Our Case Number: ABP-316272-23

Re: Bus Connects Templeogue/Rathfarnham to City Centre Core Bus Corridor Scheme
Templeogue/Rathfarnham to City Centre

From: LAPS
Sent: Tuesday 26 March 2024 13:39
To: Peter Lynch
Subject: RE: Proposed Compulsory Purchase Order - ABP 316377 - Plot No. 1026 - Peter Lynch (55 Rathfarnham Road, Dublin 6W)

Figure 2 – Profile for #55 Rathfarnham Road

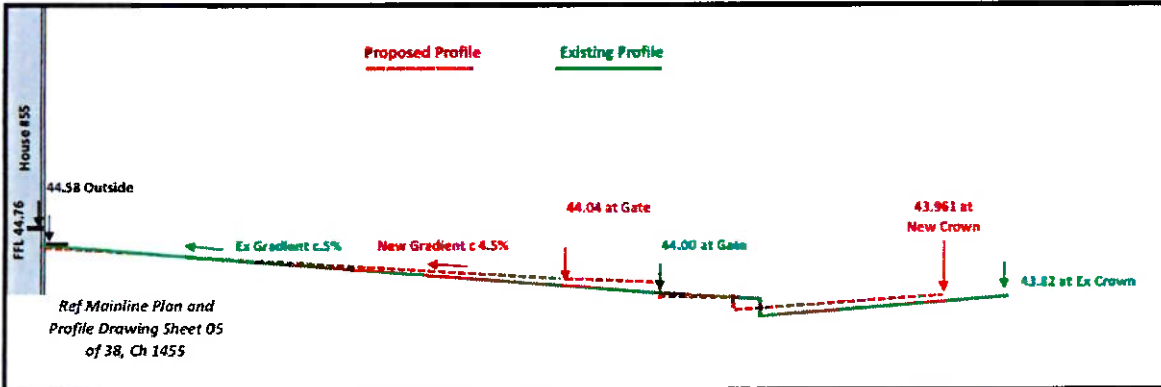
House Details	Current Total Gradient ¹	Future Total Gradient ²	Comment
55 Rathfarnham Rd	5%	4.5%	Improvement
59 Rathfarnham Rd	7.6%	9.6%	Significantly Steeper
61 Rathfarnham Rd	7.6%	8.9%	Significantly Steeper
63 Rathfarnham Rd	6.3%	10.5%	Significantly Steeper
65 Rathfarnham Rd	9.6%	11.1%	Significantly Steeper
67 Rathfarnham Rd	10.6%	13.6%	Significantly Steeper
71 Rathfarnham Rd	8.2%	9.3%	Steeper

We conclude that the Bus Connect plans (as per the Planning Application, based on the design data provided) appear to result in a significantly steeper approach to the majority of the subject dwellings, clearly contravening National Building Control Regulations.

Figure 4 – Profile for #63 Rathfarnham Road

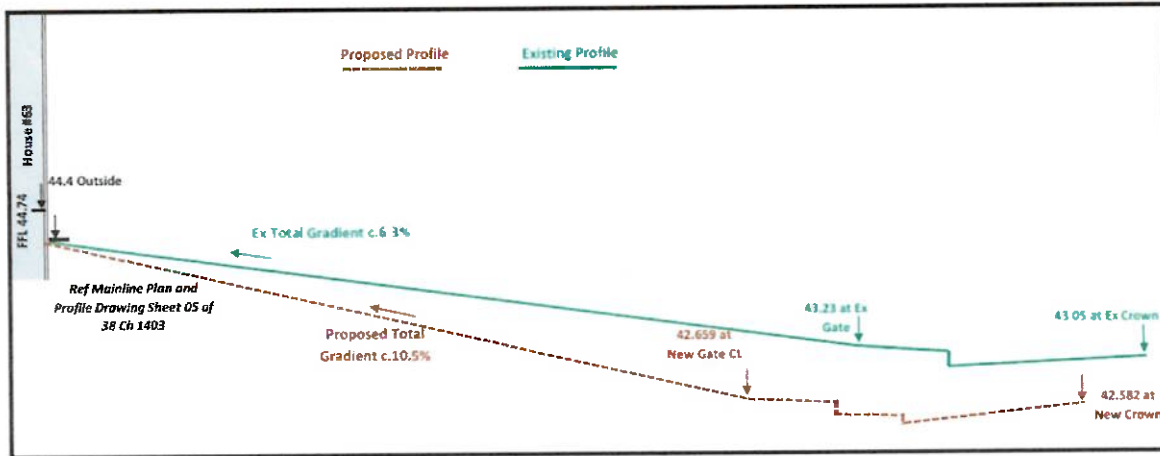
House Details	Current Total Gradient ¹	Future Total Gradient ²	Comment
55 Rathfarnham Rd	5%	4.5%	Improvement
59 Rathfarnham Rd	7.6%	9.6%	Significantly Steeper
61 Rathfarnham Rd	7.6%	8.9%	Significantly Steeper
63 Rathfarnham Rd	6.3%	10.5%	Significantly Steeper
65 Rathfarnham Rd	9.6%	11.1%	Significantly Steeper
67 Rathfarnham Rd	10.6%	13.6%	Significantly Steeper
71 Rathfarnham Rd	8.2%	9.3%	Steeper

We conclude that the Bus Connect plans (as per the Planning Application, based on the design data provided) appear to result in a significantly steeper approach to the majority of the subject dwellings, clearly contravening National Building Control Regulations.
